CROW BUTTE RESOURCES, INC.

Re: Annual Report of Changes, Tests, or Experiments
License No. SUA-1534
Docket No. 40-8943

2006 SERP Evaluation Index

Evaluation Report – SERP 06-01

Figure 5.1-1: Crow Butte Resources Organizational Chart

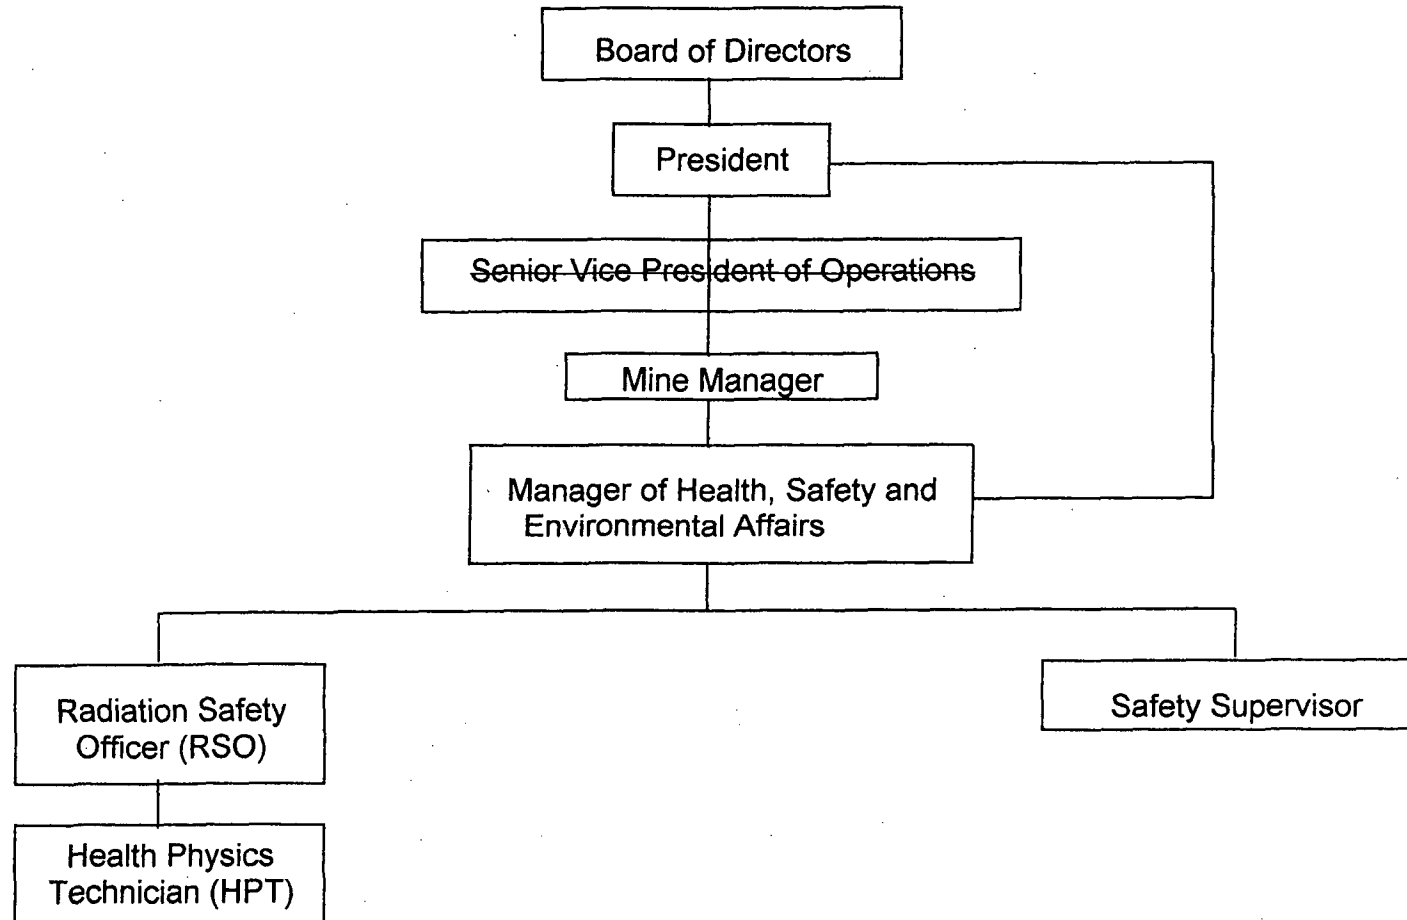
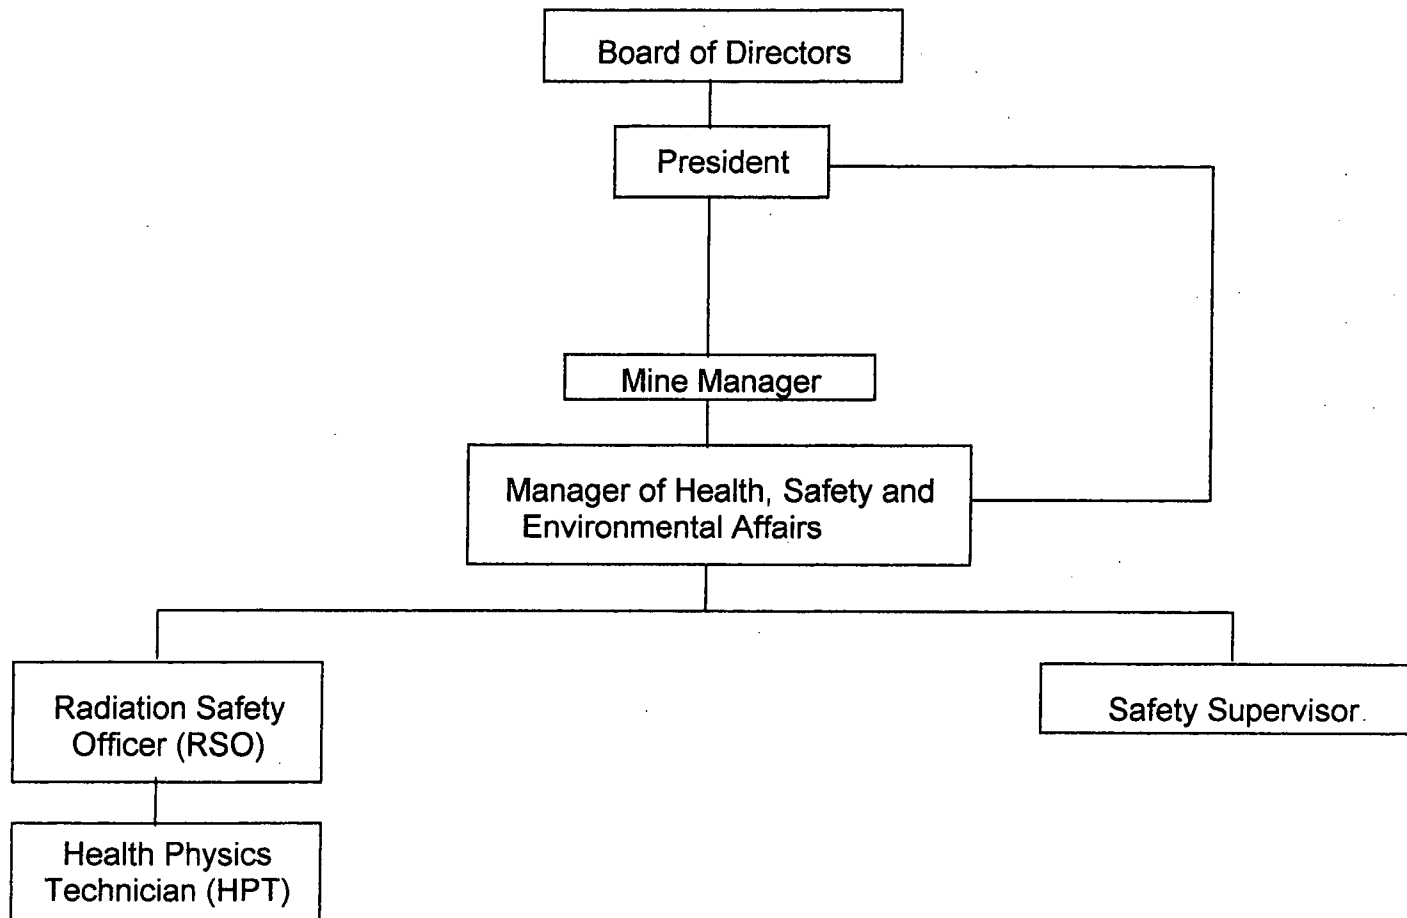
The purpose of the SERP evaluation was to review a change made to the Corporate organizational structure. Specifically, to remove the position of Senior Vice President of Operations and combine those duties with the President.

An organizational change has been made that indirectly affects the reporting responsibilities of the radiation safety staff. The reporting for the Mine Manager has been changed as shown in the revised Figure 5.1-1 from the approved application. The Mine Manager now reports directly to the President. Since the RSO reports to the Manager of Health, Safety, and Environmental Affairs who in turn reports to the Mine Manager, a change in the reporting for the Mine Manager will indirectly affect the radiation safety staff reporting.

~~5.1.3. SENIOR VICE PRESIDENT - OPERATIONS~~

~~The overall responsibility for the radiation, environmental, and safety activities of at the Crow Butte Facility rests with the Senior Vice President of Operations. The Senior Vice President of Operations reports to tThe President and is directly responsible for ensuring that CBR personnel comply with industrial safety, radiation safety, and environmental protection programs as established in the EMS Program. The Senior Vice President of Operations is also responsible for company compliance with all regulatory license conditions/stipulations, regulations and reporting requirements. The Senior Vice President of Operations has the responsibility and authority to terminate immediately any activity that is determined to be a threat to employees or public health, the environment, or potentially a violation of state or federal regulations. The Senior Vice President of Operations is also responsible for license development and license modifications.~~

5.1.4.5.1.3. MINE MANAGER

Figure 5.1-1: Crow Butte Resources Organizational Chart

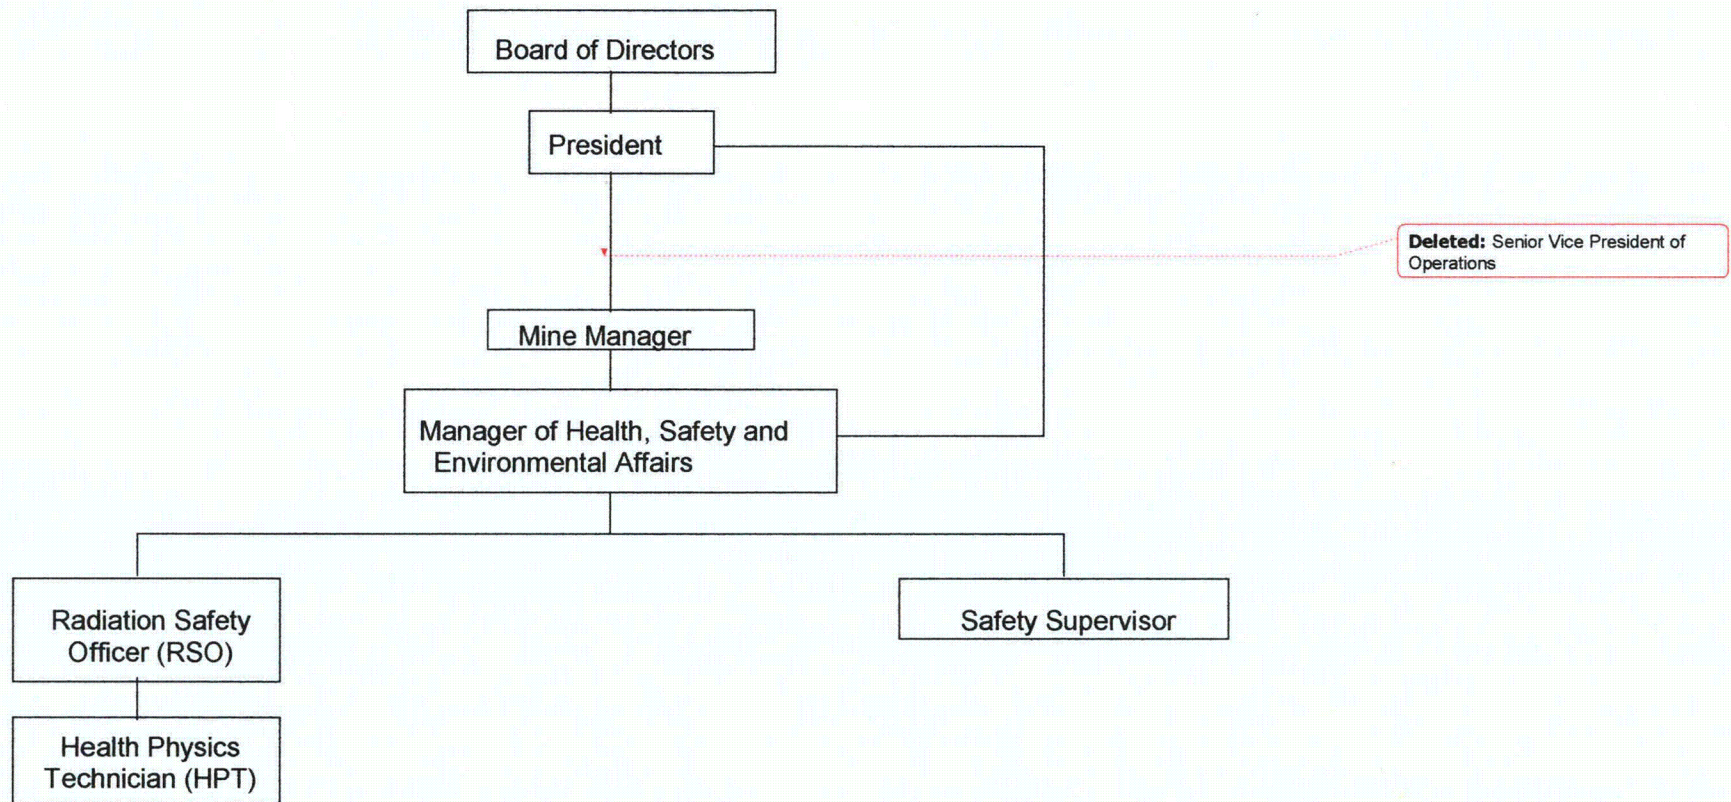
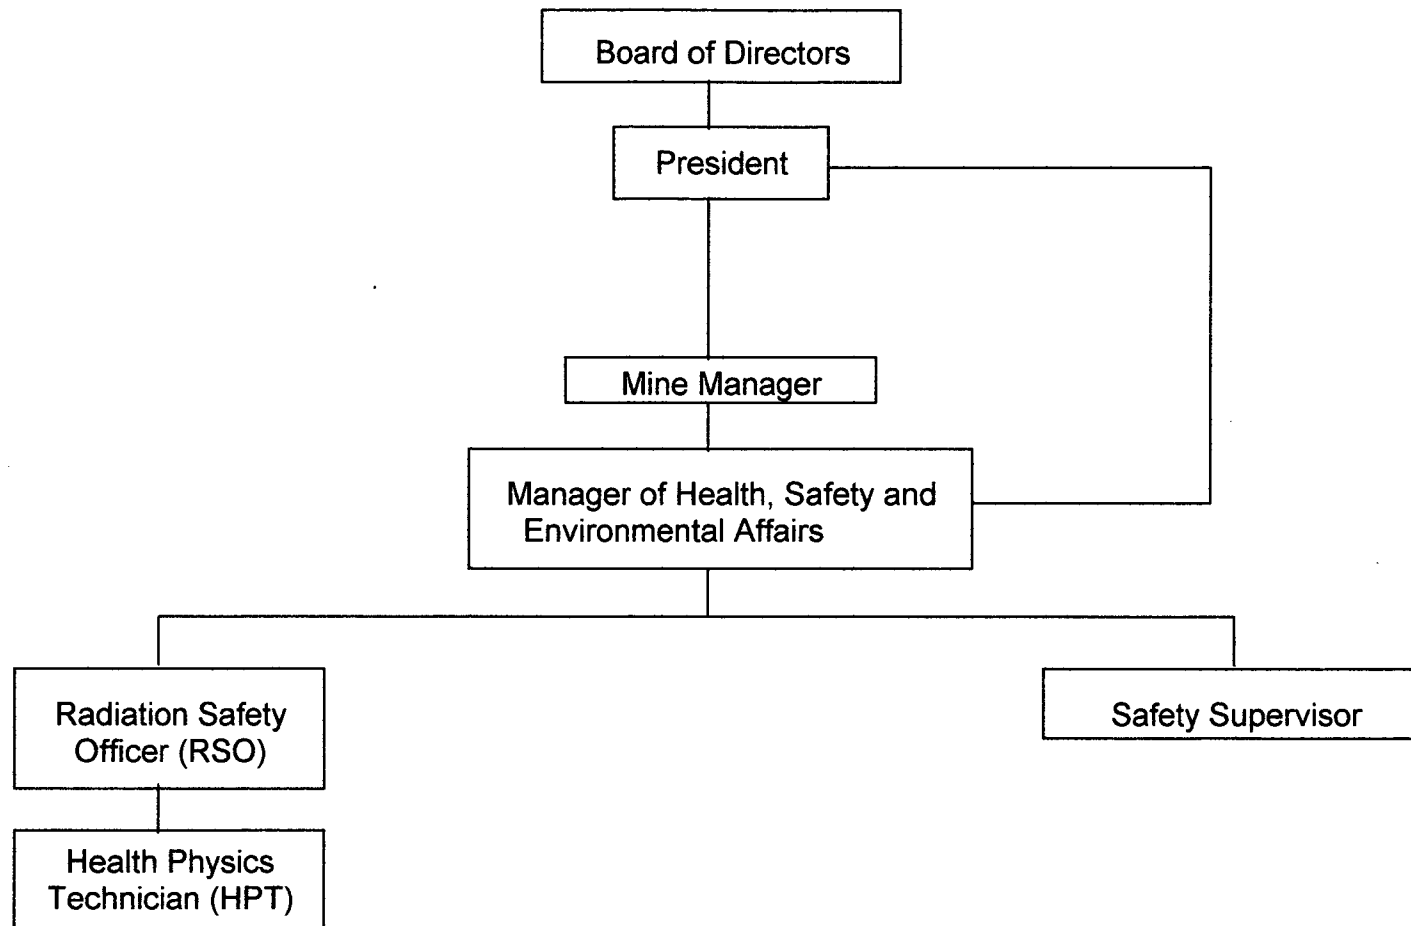
Figure 5.1-1 is a partial organization chart for CBR with respect to the operation of the Crow Butte Uranium Project and associated operations and represents the management levels that play a key part in the EMS Program. The personnel identified are responsible for the development, review, approval, implementation, and adherence to operating procedures, radiation safety programs, environmental and groundwater monitoring programs as well as routine and non-routine maintenance activities. These individuals may also serve a functional part of the Safety and Environmental Review Panel (SERP) described under Section 5.3.3.

Inserted: .

Inserted: T

Deleted: February 23, 2004
